SERVICE BULLETIN

Classification: TF02-001	Reference: NTB02-019	Date: February 19, 2002
-----------------------------	-------------------------	----------------------------

1999-2002 FRONTIER & 2000-2002 XTERRA "BEARING NOISE" FROM TRANSFER CASE AREA

APPLIED VEHICLES: 1999-2002 Frontier (D22)
2000-2002 Xterra (WD22)

Figure 1

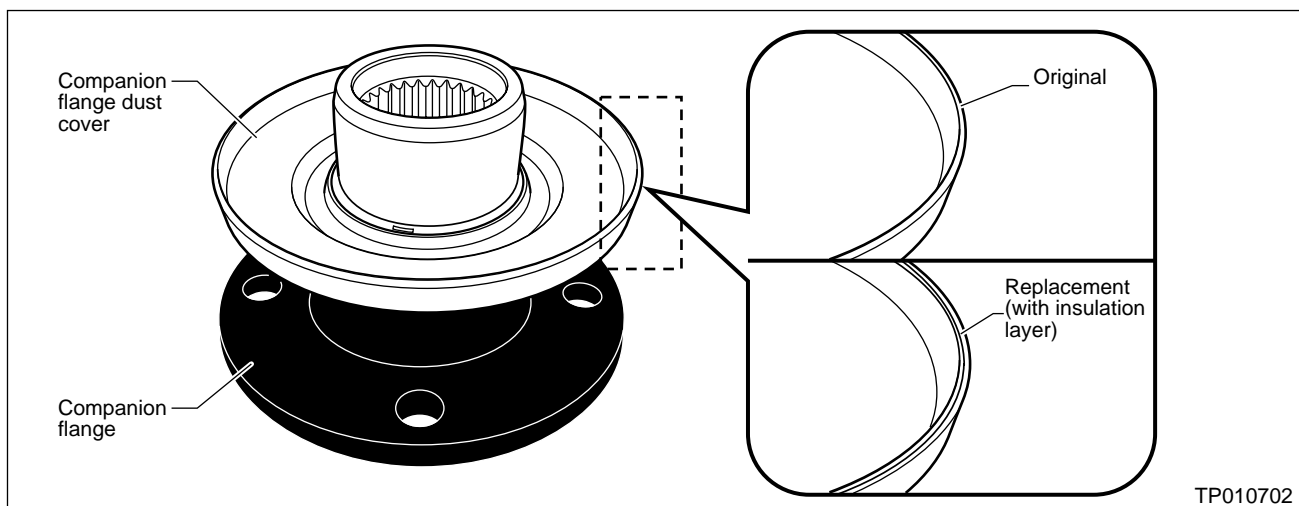
The original transfer case companion flange dust cover may be amplifying the sound of the bearing.

- A replacement companion flange designed to dampen the noise emitted from the bearing, should it occur, has been developed (see Figure 1).
- Use the Service Procedure provided in this bulletin to verify and repair this incident, if it should occur.

3. Install the replacement companion flange and self-locking nut (see the PARTS INFORMATION section for more information) and re-assemble the parts removed in Step 2 in reverse order. Torque the self-locking nut to 226-324 N-m (23.0-33.0 kg-m, 166-239 ft-lbs.)
